Reply to ATCB comments

Reference from ATCB:
e-mail dated September 29, 2005
Subject: QTLRH-74_ATCB002798

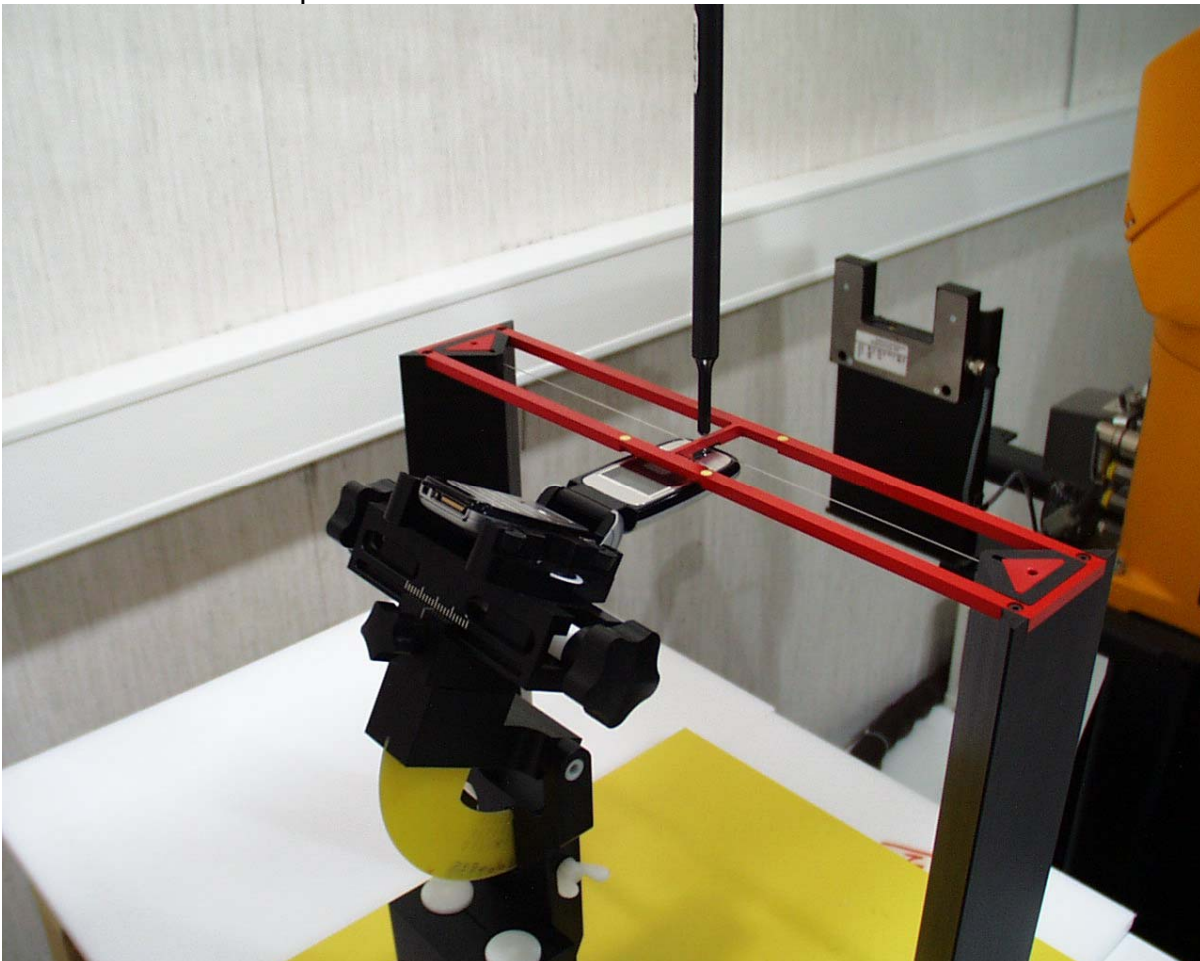
- 2 Please note that HAC is an in air measurement and a phantom is not used in HAC testing and therefore is not an appropriate uncertainty consideration.

2) We are using Hearing Aid Compatibility measurement software and instrumentation of SPEAG (Schmid & Partner Engineering AG). The specially designed Test Arch allows a high precision positioning of both the device and any of the calibration dipoles. In the SPEAG Manual and in the SPEAG software the Test Arch is named "Test Arch phantom" or only "Phantom". This may be misleading, because HAC measurement is not done in a phantom (or in a liquid and in a phantom, as it is in a case of SAR measurement). HAC measurement is done in air and Test Arch is used only for positioning WD or dipole. Test Arch itself is positioned on a stable surface (e.g. on a table). For improved user friendliness a predefined configuration file of the Test Arch is provided by SPEAG.

Please see also the photo below:

- Test Arch has yellow bottom plate, red top frames (two parallel frames with yellow markings, and one middle bar), and the dielectric wire, which is parallel with longer red top frames and perpendicular to the red middle bar.

- Yellow markings on the red top frames are the reference points. The reference points define the 5 by 5 cm area with respect to the x- and y-axis with the origin in the center. The reference points are taught to the probe.

- The z-coordinate of this plane is located at the known nominal height above the yellow base plate of the Test Arch.
- WD is mounted in so, that its acoustic output is coinciding with the center point of the area formed by the dielectric wire and the middle bar of the Test Arch's red top frame.

- Based on the certain position of the WD in respect to the Test Arch and on the known reference points of the Test Arch, the accurate distance between WD and probe's measuring element can be defined and used during HAC measurements.
